REQUEST

Current Zoning: MUDD-O (mixed use development, optional)
Proposed Zoning: MUDD-O SPA (mixed use development, optional, site plan amendment)

Approximately 0.82 acres located on the south side of Montford Drive, east of Park Road
(Council District 6 - Bokhari)

The petition proposes a site plan amendment to a previously approved site plan allowing redevelopment of an infill parcel for a mixed use commercial building in the Montford Park area south of the Park Road Shopping Center.

• **Proposed Request Details**

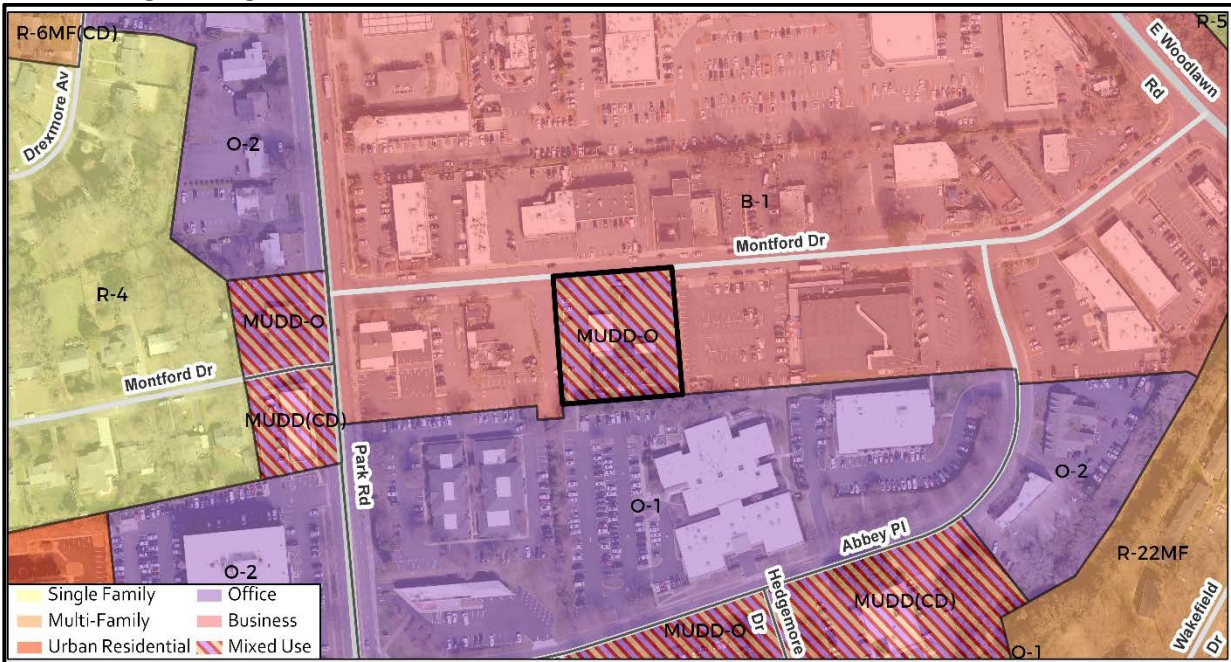
1. ~~Amend the sidewalk and planting strip shown along the unnamed side street to match what is stated in Note 5.a. specifying a 16-foot setback with an eight-foot planting strip, with hardscape sections connecting the curb to the sidewalk a minimum eight-foot sidewalk which may extend to the building façade.~~ Addressed.
2. ~~Amend the label for the setback on the unnamed side street to specify if it is existing or future back-of-curb.~~ Addressed, the existing curb line is specified because the curb is in the future location.

3. Revise the site plan and conditional notes to stub across access drive to the adjacent parcel (PID 17514501) per Transportation Policy T-4 in the *Park Woodlawn Area Plan*. Staff rescinded this request. The petitioner has stated that cross access would impede the proposed parking structure and that the neighboring property does not support cross access. The prior rezoning did not include cross access.

4. Revise the site plan to create bump outs for on-street parking on Montford Drive. Addressed; the petitioner has committed to provide a bump out on Montford Drive at the unnamed street. The petitioner has stated that there is not infrastructure at this location to deal with potential water runoff issues from additional bump outs along Montford. The petitioner will further discuss these matters at permitting should the infrastructure exist at that time. During the prior rezoning similar stormwater issues along Montford Road were discussed. The proposed streetscaping is the same as approved by Council with staff support.
